Access Audit Site Report

Meridian State Park

Accessibility Evaluation

**TEXAS PARKS AND WILDLIFE DEPARTMENT
MERIDIAN STATE PARK**

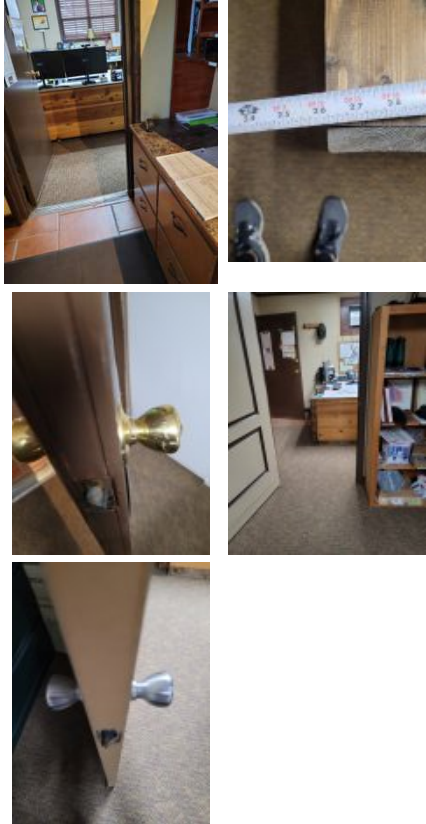
Finding Number	Area Description	Lat/Long	Finding	As Built	Recommendation	Citation	Photos	Figure
16	Exterior: Parking	[31.8888307 , -97.6994864]	There are no or not enough accessible parking stalls. Each lot where parking is provided for the public as clients, guests or employees, shall provide accessible parking and shall be located on the shortest accessible route of travel from adjacent parking to an accessible entrance. There are a total of (XX) parking stalls in the parking lot that could be reasonably associated with this facility. There should be a minimum of (XX) accessible stalls with a minimum of (XX) being designed as van accessible.	28 standard parking spaces, 1 accessible parking space	Create one or more 8' accessible parking stalls, with one 5' adjacent access aisle, with proper signage and striping based on the total number of stalls.	2015 ABAAS Section: F208.2 2012 TAS Section: 208.2 2010 ADAS Section: 208.2

17	Exterior: Parking	[31.8889969 , -97.699709]	There are no van accessible parking stalls. 1 in every 6, minimum of one, required accessible stalls must be a van accessible stall. There are a total of 30 parking stalls in the parking lot that could be reasonably associated with this facility. There should be a minimum of (2) accessible stalls with a minimum of (1) being designed as van accessible.	Lacks van accessible parking stall, approximately 30 stalls, 1 accessible	Add van parking sign to 1 accessible stall and repaint stall and access aisle to 11' and 5' or 8' and 8' per the table	2015 ABAAS Section: F208.2, F208.2.4 2012 TAS Section: 208.2, 208.2.4 2010 ADAS Section: 208.2, 208.2.4

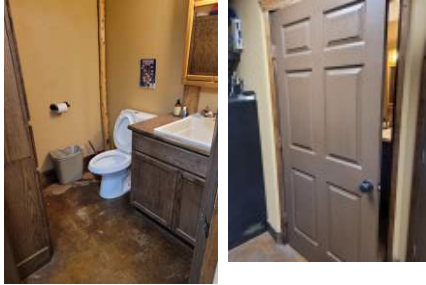
Finding Number	Area Description	Lat/Long	Finding	As Built	Recommendation	Citation	Photos	Figure
18	Exterior: Parking	[31.8890106 , -97.699714 4]	The cross slopes (narrow dimension) and/or running slopes (long dimension) of the access aisle exceeds 2%. The running slope and the cross slope in an accessible parking stall and the access aisle must not exceed 2%.	Lakeside restroom building - 7.7% in stall, 14.5% in access aisle	Repair or correct slope of parking space and access aisle to max 2.08% in any direction	2015 ABAAS Section: 502.4 2012 TAS Section: 502.4 2010 ADAS Section: 502.4		
19	Exterior: Parking	[31.8913039 , -97.701491 4]	There are no accessible parking stalls. Each lot where parking is provided for the public as clients, guests or employees, shall provide accessible parking and shall be located on the shortest accessible route of travel from adjacent parking to an accessible entrance. There are a total of (16) parking stalls in the parking lot that could be reasonably associated with this facility. There should be a minimum of (1) accessible stalls with a minimum of (1) being designed as van accessible.	Juniper ridge bath house - 16 parking spaces, no accessible parking spaces	Create one or more 8' accessible parking stalls, with one 5' adjacent access aisle, with proper signage and striping based on the total number of stalls	2015 ABAAS Section: F208.2 2012 TAS Section: 208.2 2010 ADAS Section: 208.2

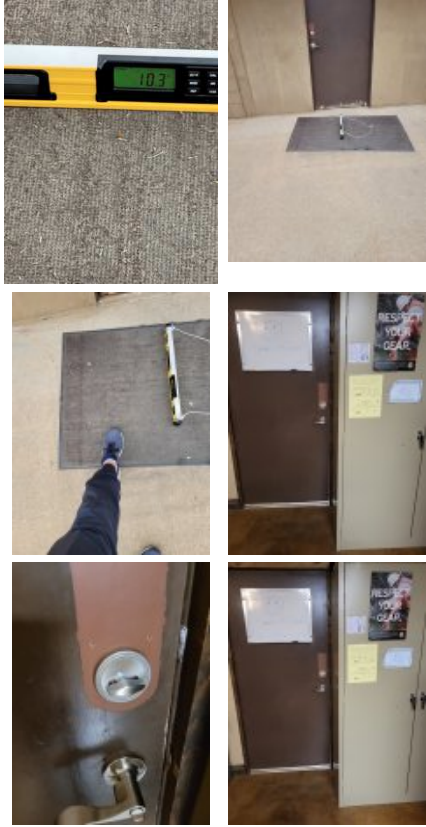
Finding Number	Area Description	Lat/Long	Finding	As Built	Recommendation	Citation	Photos	Figure
20	Exterior: Parking	[31.8929561 , -97.702337 6]	There are no accessible parking stalls. Each lot where parking is provided for the public as clients, guests or employees, shall provide accessible parking and shall be located on the shortest accessible route of travel from adjacent parking to an accessible entrance. There are a total of (6) parking stalls in the parking lot that could be reasonably associated with this facility. There should be a minimum of (1) accessible stalls with a minimum of (1) being designed as van accessible.	Juniper by bird blind - 6 parking spaces, lacks accessible parking	Create one or more 8' accessible parking stalls, with one 5' adjacent access aisle, with proper signage and striping based on the total number of stalls	2015 ABAAS Section: F208.2 2012 TAS Section: 208.2 2010 ADAS Section: 208.2

21	Exterior: Parking	[31.8956011 , -97.702284]	There are no accessible parking stalls. Each lot where parking is provided for the public as clients, guests or employees, shall provide accessible parking and shall be located on the shortest accessible route of travel from adjacent parking to an accessible entrance. There are a total of (12) parking stalls in the parking lot that could be reasonably associated with this facility. There should be a minimum of (1) accessible stalls with a minimum of (1) being designed as van accessible.	Northern most parking area - estimated 12 parking spaces in gravel loop lot, 0 accessible.	Create one or more 8' accessible parking stalls, with one 5' adjacent access aisle, with proper signage and striping based on the total number of stalls	2015 ABAAS Section: F208.2 2012 TAS Section: 208.2 2010 ADAS Section: 208.2		
22	Exterior: Parking	[31.8908302 , -97.697625]	There are no accessible parking stalls. Each lot where parking is provided for the public as clients, guests or employees, shall provide accessible parking and shall be located on the shortest accessible route of travel from adjacent parking to an accessible entrance. There are a total of (4) parking stalls in the parking lot that could be reasonably associated with this facility. There should be a minimum of (1) accessible stalls with a minimum of (1) being designed as van accessible.	Headquarters - 0 of 4 parking stalls are accessible	Create one or more 8' accessible parking stalls, with one 5' adjacent access aisle, with proper signage and striping based on the total number of stalls	2015 ABAAS Section: F208.2 2012 TAS Section: 208.2 2010 ADAS Section: 208.2

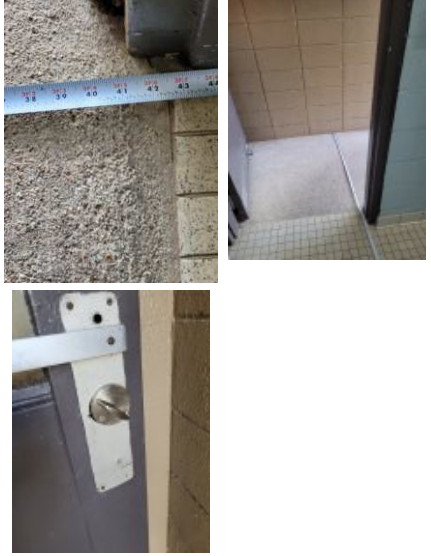
Finding Number	Area Description	Lat/Long	Finding	As Built	Recommendation	Citation	Photos	Figure
53	Crosstimbers Campground: Accessible Cabin 9	[31.8897143 , -97.699038 5]	The operable part is positioned too high for either a side or front approach. Where a clear floor or ground space allows a parallel approach to an element and the side reach is unobstructed, the high side reach shall be 48 inches maximum and the low side reach shall be 15 inches minimum above the finish floor or ground. Where a forward reach is unobstructed, the high forward reach shall be 48 inches maximum and the low forward reach shall be 15 inches minimum above the finish floor or ground.	Cabin 9 - AC unit controls 67" above finished floor	Remount operable parts to be in reach range of 15" min to 48" max	2015 ABAAS Section: 308.1 2012 TAS Section: 308.1 2010 ADAS Section: 308.1		
54	Crosstimbers Campground: Accessible Cabin 9	[31.8897052 , -97.699030 4]	The top of the work surface is not within a compliant height range. The tops of tables and counters shall be 28 inches to 34 inches from the floor or ground.	Cabin 9 - table lacks knee and toe clearance	Provide tables and work surfaces at 28" to 34" aff with required knee and toe clearances	2015 ABAAS Section: 902.3 2012 TAS Section: 902.3 2010 ADAS Section: 902.3

55	Crosstimbers Campground: Accessible Cabin 9	[31.8896938 , -97.699030 4]	Minimum maneuvering clearances at doors and gates shall comply with 404.2.4. Maneuvering clearances shall extend the full width of the doorway and the required latch side or hinge side clearance. Maneuvering clearances shall have a max slope of 2.08%. The threshold at a doorway shall be no higher than 1/2 inch. Changes in level between 1/4 inch and 1/2 inch must be beveled at 1:2 or less. 1/4 inch is the maximum vertical rise.	Cabin 9 - 5.5" maneuvering clearance on pull side, 0.75" threshold	For all doors along the public circulation route, provide required maneuvering clearance on push and pull side of doors. For all doors along the public circulation route, provide beveled threshold.	2010 ADAS Section: 404.2.3, 404.2.7, 404.2.4, 404.2.11, 404.2.11 Exception

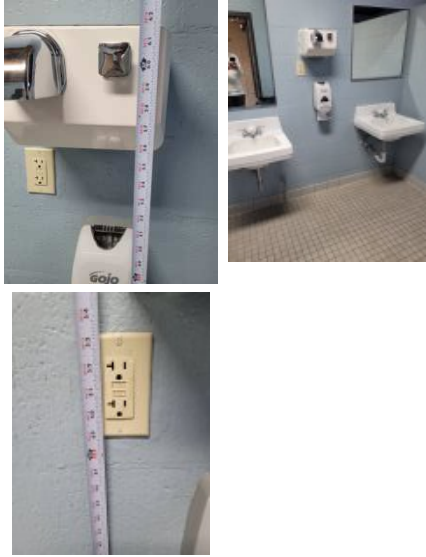
Finding Number	Area Description	Lat/Long	Finding	As Built	Recommendation	Citation	Photos	Figure
60	Crosstimbers Campground: Accessible Cabin 9	[31.8896893 , -97.6990412]	Where provided, cooking surfaces shall be 15 inches (380 mm) minimum and 34 inches (865 mm) maximum above the ground	35" to bottom level cooking surface	Raise or lower cooking surface to be 15" min to 34" max above the ground; in the alternative, replace with a compliant surface as a smart practice	2015 ABAAS Section: 1011.5.2		
61	Crosstimbers Campground: Accessible Cabin 9	[31.8897075 , -97.6990734]	Parking spaces and pull-up spaces for recreational vehicles shall be 20 feet (6100 mm) wide minimum. EXCEPTION: Where two adjacent parking spaces are provided for recreational vehicles, one parking space shall be permitted to be 16 feet (4880 mm) wide minimum.	Cabin 9 - parking space 12' wide	Correct RV parking space to be 20' wide minimum; or 16' for two adjacent spaces as a smart practice.	2015 ABAAS Section: 1012.2, 1012.2 EXCEPTION

62	Crosstimbers Campground: Accessible Cabin 9	[31.8897166 , -97.6990734]	30 inches (760 mm) by 60 inches (1525 mm) with the long side of the space adjoining or overlapping an accessible parking space or pull-up space for recreational vehicles Locate the space so that the hook-ups are at the rear center of the space. Bollards or other barriers shall not obstruct the clear ground space in front of the hook-ups	Cabin 9 - lacks clear ground space at utility hookups	Provide required 30" by 60" clear ground space with hook ups at the rear of the space as a smart practice	2015 ABAAS Section: 1011.2		
63	Crosstimbers Campground: Accessible Cabin 9	[31.8896938 , -97.699076]	There is no accessible route to the cabin entry. At least one accessible route shall connect accessible buildings, accessible facilities, accessible elements, and accessible spaces that are on the same site.	Cabin 9 - lacks accessible route to entry due to unstable surface	Create an accessible route with crushed stone or other outdoor material from parking or walkway to cabin entry	2015 ABAAS Section: F206.2.2 2012 TAS Section: 206.2.2 2010 ADAS Section: 206.2.2

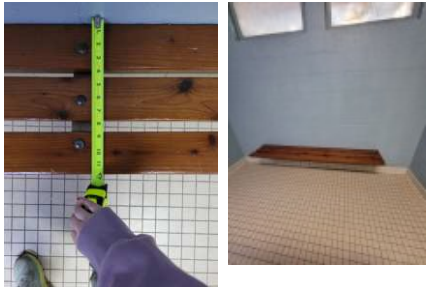
Finding Number	Area Description	Lat/Long	Finding	As Built	Recommendation	Citation	Photos	Figure
74	Crosstimbers Campground: Crosstimbers - Men's Restroom	[31.8900514 , -97.6985315]	The stall door fails to comply with all of the door requirements. The stall door must be a minimum of 32" wide and have compliant hardware on both sides. The stall door must be self-closing.	stall door not self closing	Adjust stall door to be self-closing	2015 ABAAS Section: 404.2.3, 404.2.7, 604.8.2.2 2012 TAS Section: 404.2.3, 404.2.7, 604.8.2.2 2010 ADAS Section: 404.2.3, 404.2.7, 604.8.2.2		
75	Crosstimbers Campground: Crosstimbers - Men's Restroom	[31.8900468 , -97.6985262]	The side grab bars are not in the correct location. Grab bars on the side wall must be installed so that the end closest to the rear wall is maximum 12" from the rear wall. The end furthest from the rear wall must be mounted minimum 54" from the rear wall.	Men's restroom - side grab bar installed 47.75" from back wall	Remount side grab bar to max 12" from the rear wall at the close end and min 54" on the far end, and 33" to 36" aff.	2015 ABAAS Section: 604.5.1 2012 TAS Section: 604.5.1 2010 ADAS Section: 604.5.1

76	Crosstimbers Campground: Crosstimbers - Men's Restroom	[31.8900468 , -97.6985315]	The toilet paper is not installed within the compliant range in front of the toilet. Toilet paper dispensers shall be 7 inches minimum and 9 inches maximum in front of the water closet measured to the centerline of the dispenser. The outlet of the dispenser shall be 15 inches minimum and 48 inches maximum above the finish floor and shall not be located behind grab bars. Dispensers shall not be of a type that controls delivery or that does not allow continuous paper flow. There shall be a clearance of 1 1/2 inches minimum below the grab bar.	Men's restroom - toilet paper dispenser too close	Remount toilet paper dispenser 7" to 9" from front of toilet, 15" to 48" AFF and min 12" above or 1.5" below grab bar.	2015 ABAAS Section: 604.7 2012 TAS Section: 604.7 2010 ADAS Section: 604.7

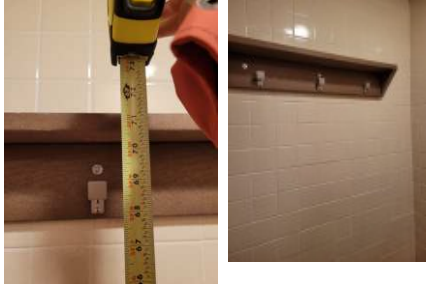
Finding Number	Area Description	Lat/Long	Finding	As Built	Recommendation	Citation	Photos	Figure
91	Crosstimbers Campground: Crosstimbers - Women's Restroom	[31.8900764 , -97.698530 2]	The shower seat does not have a compliant space between it and the wall. The folding seat must be mounted 17-19 inches above the floor, and have a maximum space of 1-1/2 inches between the edge of the seat and the side wall and 2-1/2 inches maximum to the seat wall.	Women's restroom - shower seat installed 3.25" from back wall	Remount shower seat to the correct location and height in the shower	2015 ABAAS Section: 610.3.2 2012 TAS Section: 610.3.2 2010 ADAS Section: 610.3.2		
92	Crosstimbers Campground: Crosstimbers - Dump Station	[31.8898305 , -97.698641 5]	30 inches (760 mm) by 60 inches (1525 mm) with the long side of the space adjoining or overlapping an accessible parking space or pull-up space for recreational vehicles. Locate the space so that the hook-ups are at the rear center of the space. Bollards or other barriers shall not obstruct the clear ground space in front of the hook-ups	lacks clear ground space at utility hookup	Provide required 30" by 60" clear ground space with hook ups at the rear of the space as a smart practice	2015 ABAAS Section: 1011.2

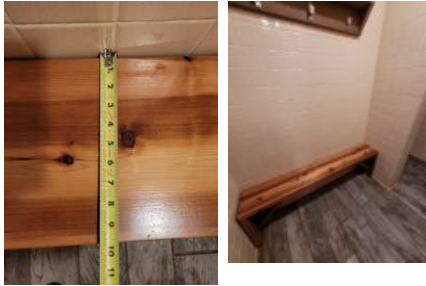
Finding Number	Area Description	Lat/Long	Finding	As Built	Recommendation	Citation	Photos	Figure
93	Juniper Ridge Campground: Accessible Shelter 18	[31.8912686 , -97.700933 5]	Element meets all standards and requirements	Shelter 18 complies	None	2010 ADAS Section: N/A		
94	Juniper Ridge Campground: Accessible Shelter 18	[31.8912629 , -97.700917 4]	Thresholds, if provided at doorways, shall be 1/2 inch (13 mm) high maximum. Raised thresholds and changes in level at doorways shall comply with 302 and 303. Changes in level of 1/4 inch (6.4 mm) high maximum shall be permitted to be vertical. Changes in level between 1/4 inch (6.4 mm) high minimum and 1/2 inch (13 mm) high maximum shall be beveled with a slope not steeper than 1:2. Changes in level greater than 1/2 inch (13 mm) high shall be ramped, and shall comply with 405 or 406.	2.75" change in elevation at entry	Repair, bevel or ramp CIL at doorway	2015 ABAAS Section: 303.3, 404.2.5, 303.2, 303.4 2012 TAS Section: 303.3, 404.2.5, 303.2, 303.4 2010 ADAS Section: 303.3, 404.2.5, 303.2, 303.4

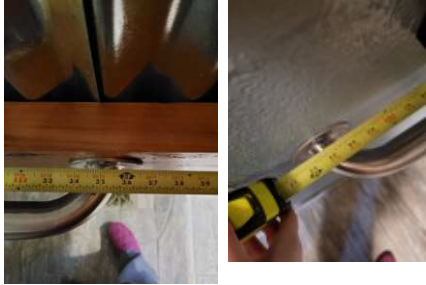
Finding Number	Area Description	Lat/Long	Finding	As Built	Recommendation	Citation	Photos	Figure
103	Juniper Ridge Campground: Juniper Ridge - Men's Restroom	[31.8912356 , -97.701541]	The bench is not deep enough or long enough or is missing. Benches shall be provided having seats that are 42 inches long minimum and 20 inches deep minimum and 24 inches deep maximum. The bench shall provide for back support or shall be affixed to a wall. Back support shall be 42 inches (1065 mm) long minimum and shall extend from a point 2 inches (51 mm) maximum above the seat surface to a point 18 inches (455 mm) minimum above the seat surface. Back support shall be 2½ inches (64 mm) maximum from the rear edge of the seat measured horizontally. The top of the bench seat surface shall be 17 inches (430 mm) minimum and 19 inches (485 mm) maximum above the finish floor or ground.	Men's restroom - bench 9.5" depth	Replace bench in dressing area with one having a seat depth of 20" to 24" deep, 42" long, affixed to the wall or having a back and mounted 17" to 19" aff	2012 TAS Section: 903.4, 903.2, 903.3, 903.5 2010 ADAS Section: 903.4, 903.2, 903.3, 903.5

104	Juniper Ridge Campground: Juniper Ridge - Men's Restroom	[31.8912402 , -97.7015517]	There are no accessible bathing or shower facilities. Where facilities for bathing are provided for the public, clients or employees, including showers or bathtubs, at least one shower or bathtub and support facilities such as lockers, and not less than 1 percent of all facilities, shall be accessible.	Men's restroom - lacks accessible shower stall	Create an accessible shower in locker/bathing room	2015 ABAAS Section: F213.3.6 2012 TAS Section: 213.3.6 2010 ADAS Section: 213.3.6

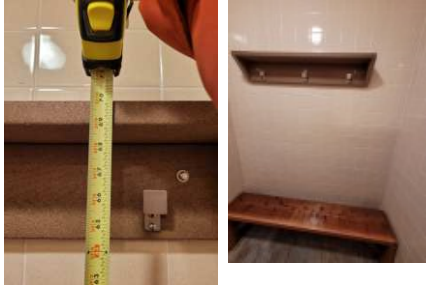
Finding Number	Area Description	Lat/Long	Finding	As Built	Recommendation	Citation	Photos	Figure
108	Juniper Ridge Campground: Juniper Ridge - Men's Restroom	[31.891231, -97.701530 3]	The operable part is positioned too high for either a side or front approach. Where a clear floor or ground space allows a parallel approach to an element and the side reach is unobstructed, the high side reach shall be 48 inches maximum and the low side reach shall be 15 inches minimum above the finish floor or ground. Where a forward reach is unobstructed, the high forward reach shall be 48 inches maximum and the low forward reach shall be 15 inches minimum above the finish floor or ground.	Men's restroom - paper towels 60" above finished floor	Remount operable parts to be in reach range of 15" min to 48" max	2015 ABAAS Section: 308.1 2012 TAS Section: 308.1 2010 ADAS Section: 308.1		
109	Juniper Ridge Campground: Juniper Ridge - Men's Restroom	[31.891231, -97.701530 3]	There are not enough accessible toilet compartments. The room contains toilet compartments. A minimum of 1 must be wheelchair accessible .	Men's restroom - lacks accessible toilet compartment. 1 ambulatory stall and 1 urinal	Create a wheelchair accessible stall with grab bars and fixtures mounted in correct locations and at correct heights.	2015 ABAAS Section: F213.3.1 2012 TAS Section: 213.3.1 2010 ADAS Section: 213.3.1

110	Juniper Ridge Campground: Juniper Ridge - Men's Restroom	[31.8912447, -97.701535 6]	The ambulatory stall is not between 35" to 37" wide and 60" deep.	Men's restroom - ambulatory stall 40" width by 60" depth	Correct ambulatory stall to be 35" to 37" wide and minimum 60" deep	2015 ABAAS Section: 604.8.2.1 2012 TAS Section: 604.8.2.1 2010 ADAS Section: 604.8.2.1

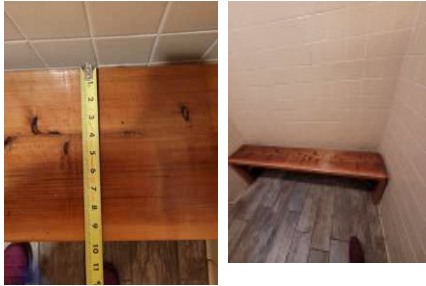
Finding Number	Area Description	Lat/Long	Finding	As Built	Recommendation	Citation	Photos	Figure
111	Juniper Ridge Campground: Juniper Ridge - Men's Restroom	[31.891247, -97.701530 3]	The toilet is not located within the range to the side wall or partition. The centerline of the toilet shall be 17 inches minimum and 19 inches maximum side wall or partition in the ambulatory accessible toilet compartment.	Men's restroom - toilet centerline 22" from partition side	Remount toilet to 17" to 19" from the side wall to center line in ambulatory stalls	2015 ABAAS Section: 604.9.1 2012 TAS Section: 604.9.1 2010 ADAS Section: 604.9.1		
112	Juniper Ridge Campground: Juniper Ridge - Men's Restroom	[31.8912219, -97.701541]	The stall door fails to comply with all of the door requirements. The stall door must be a minimum of 32" wide and have compliant hardware on both sides. The stall door must be self-closing.	Men's restroom - stall door locking hardware requires pinch	Replace stall hardware with hardware operable without a tight pinch or grasp on both sides of the stall door	2015 ABAAS Section: 404.2.3, 404.2.7, 604.8.2.2 2012 TAS Section: 404.2.3, 404.2.7, 604.8.2.2 2010 ADAS Section: 404.2.3, 404.2.7, 604.8.2.2

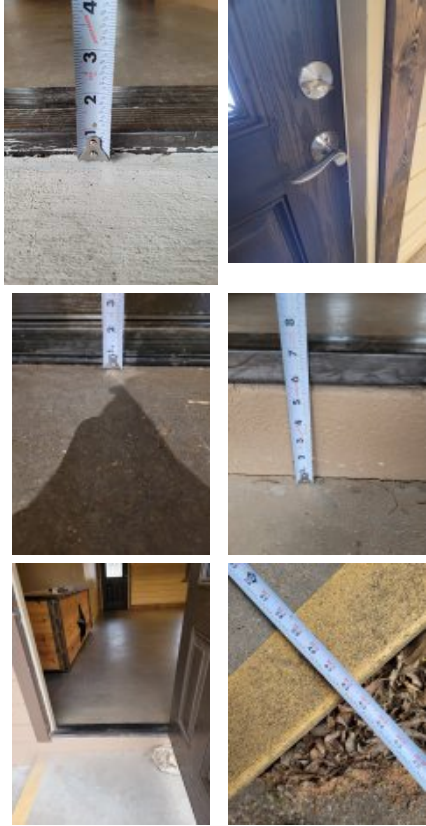
Finding Number	Area Description	Lat/Long	Finding	As Built	Recommendation	Citation	Photos	Figure
119	Juniper Ridge Campground: Juniper Ridge - Women's Restroom	[31.8912675 , -97.701578 5]	The bench is not deep enough or long enough or is missing. Benches shall be provided having seats that are 42 inches long minimum and 20 inches deep minimum and 24 inches deep maximum. The bench shall provide for back support or shall be affixed to a wall. Back support shall be 42 inches (1065 mm) long minimum and shall extend from a point 2 inches (51 mm) maximum above the seat surface to a point 18 inches (455 mm) minimum above the seat surface. Back support shall be 2½ inches (64 mm) maximum from the rear edge of the seat measured horizontally. The top of the bench seat surface shall be 17 inches (430 mm) minimum and 19 inches (485 mm) maximum above the finish floor or ground.	Women's restroom - bench 9.5" depth	Replace bench in dressing area with one having a seat depth of 20" to 24" deep, 42" long, affixed to the wall or having a back and mounted 17" to 19" aff	2012 TAS Section: 903.4, 903.2, 903.3, 903.5 2010 ADAS Section: 903.4, 903.2, 903.3, 903.5

120	Juniper Ridge Campground: Juniper Ridge - Women's Restroom	[31.891272, -97.701541]	There are no accessible bathing or shower facilities. Where facilities for bathing are provided for the public, clients or employees, including showers or bathtubs, at least one shower or bathtub and support facilities such as lockers, and not less than 1 percent of all facilities, shall be accessible.	Women's restroom - lacks accessible shower stall	Create an accessible shower in locker/bathing room	2015 ABAAS Section: F213.3.6 2012 TAS Section: 213.3.6 2010 ADAS Section: 213.3.6

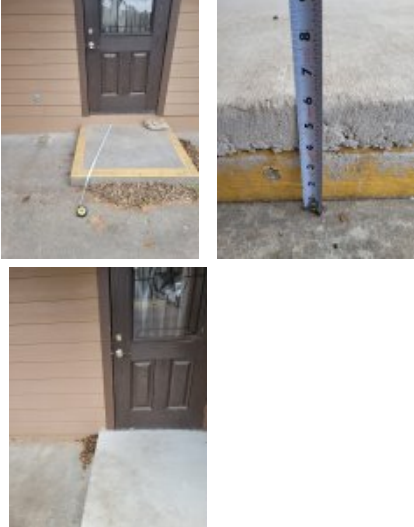
Finding Number	Area Description	Lat/Long	Finding	As Built	Recommendation	Citation	Photos	Figure
121	Juniper Ridge Campground: Juniper Ridge - Women's Restroom	[31.8912447 , -97.7015115]	Minimum maneuvering clearances at doors and gates shall comply with 404.2.4. Maneuvering clearances shall extend the full width of the doorway and the required latch side or hinge side clearance.	women's- 2.5" clearance on push, 44" width at entry	For all doors along the public circulation route, provide required maneuvering clearance on push and pull side of doors	2010 ADAS Section: 404.2.3, 404.2.7, 404.2.4, 404.2.11, 404.2.11 Exception		
122	Juniper Ridge Campground: Juniper Ridge - Dining Hall	[31.8912265 , -97.7015195]	There is no accessible route to the fire ring. At least one accessible route shall connect accessible buildings, accessible facilities, accessible elements, and accessible spaces that are on the same site.	Dining Hall - no accessible route to fire ring	Create an accessible route with crushed stone or other outdoor material from parking or walkway to fire ring	2015 ABAAS Section: F206.2.2 2012 TAS Section: 206.2.2 2010 ADAS Section: 206.2.2

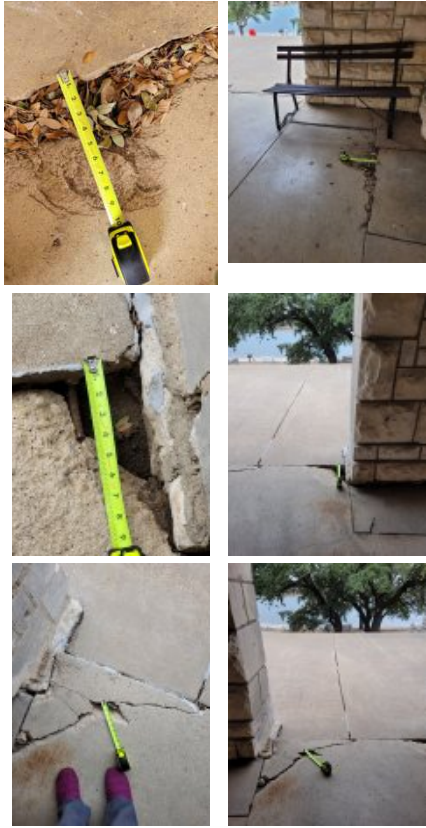
Finding Number	Area Description	Lat/Long	Finding	As Built	Recommendation	Citation	Photos	Figure
135	Juniper Ridge Campground: Juniper Ridge - Dining Hall	[31.8911946 , -97.701567 8]	Stairways must have handrails on both sides. Handrails and their extensions must be between 34 inches and 38 inches above the stair nosing or ground. The top handrails shall extend a minimum of 12 inches beyond the top nosing and shall be parallel with the floor or ground surface. At the bottom of a stair flight, handrails shall extend at the slope of the stair flight for a horizontal distance at least equal to one tread depth beyond the last riser nosing. Extension shall return to a wall, guard, or the landing surface, or shall be continuous to the handrail of an adjacent stair flight. The orientation of at least one handrail, including the extension, shall be in the direction of the run of the stair and perpendicular to the direction of the stair nosing. Handrail gripping surfaces with a circular cross section shall have an outside diameter of 1-1/4 inches minimum and 2 inches maximum. Handrail gripping surfaces with a non-circular cross section shall have a perimeter dimension of 4 inches minimum and 6 1/4 inches maximum, and a cross-section dimension of 2-1/4 inches maximum. The hand grip portion of handrails shall have a smooth surface with no sharp corners. Gripping surfaces (top or sides) shall be uninterrupted by newel posts, other construction elements or obstructions. Any wall or other surface adjacent to the handrail shall be free of sharp or abrasive elements. Handrails projecting from a wall shall have a space of 1-1/2 inches minimum between the wall and the handrail.	lacks handrail on wall side, handrail lacks extension	Install handrails on both sides of stairway, mounted 34" to 38" aff with top and bottom extensions and having a 1.25" – 2" in diameter, or a non-circular grip that has a perimeter dimension of 4"- 6.25" max with a min gap of 1.5" between handrail and wall	2015 ABAAS Section: 505.2 2012 TAS Section: 505.2 2010 ADAS Section: 505.2

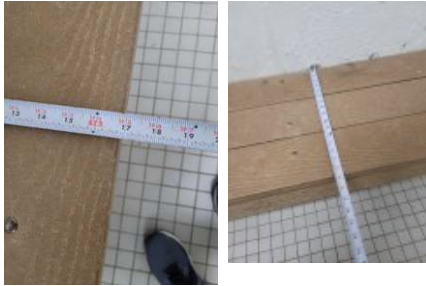
Finding Number	Area Description	Lat/Long	Finding	As Built	Recommendation	Citation	Photos	Figure
139	Lakeside Campground: Lakeside - Picnic Area	[31.8887601 , -97.699835 1]	There is a gap spaced greater than a 1/2 inch. Openings in floor or ground surfaces shall not allow passage of a sphere more than 1/2 inch diameter. Elongated openings shall be placed so that the long dimension is perpendicular to the dominant direction of travel.	Gaps - 9" on right side facing water, 7" center, 5" center	Correct or fill gaps to be max .5"	2015 ABAAS Section: 302.3 2012 TAS Section: 302.3 2010 ADAS Section: 302.3		
140	Lakeside Campground: Lakeside - Picnic Area	[31.8887601 , -97.699802 9]	Picnic tables shall provide at least one wheelchair space for each 24 linear feet (7320 mm) of usable table surface perimeter. Wheelchair spaces shall be 30 inches (760 mm) minimum by 48 inches (1220 mm) minimum. Wheelchair spaces shall be positioned for a forward approach to the table and provide knee and toe clearance complying with 306 under the table	0 of 3 picnic tables accessible	Replace picnic table with one of an accessible design as a smart practice	2015 ABAAS Section: 1011.4.2
